Service Bulletin

PRELIMINARY INFORMATION

Subject: Pop Noise From Fuel Tank After a Cold Start or EVAP Purge Event

Models: 2010 -2017 Chevrolet Equinox
2010-2017 GMC Terrain

1. Flange location of the auxiliary fuel module (sender kit)
2. Primary Pump NOT the correct component to replace (module kit)

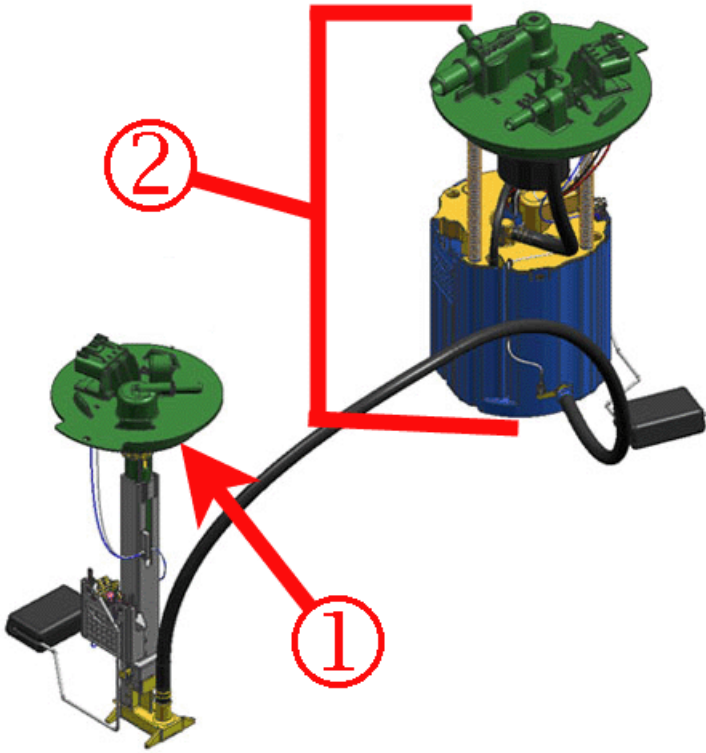
The cause for this concern is the auxiliary fuel module in the left side of the fuel tank changing height (spring loaded leg).

The part number on the box of the auxiliary fuel module has not changed but the auxiliary fuel module inside of the box has.

Important: The condition described in this PI applies only to the auxiliary fuel pump module assembly. The Parts Catalog calls this auxiliary pump component the "sender kit" which is the correct part for this repair. Replacing the primary fuel pump module assembly would NOT correct this noise condition. The parts catalog calls this primary pump component the "module kit" which is the incorrect part for this repair.

After ordering the auxiliary fuel module, remove it from the box and verify the letters "PPA" are cast into the top of the fuel module flange.

This is the revised auxiliary fuel module designed to correct the pop/popping noise. The original auxiliary fuel module has "POM" cast into the flange.
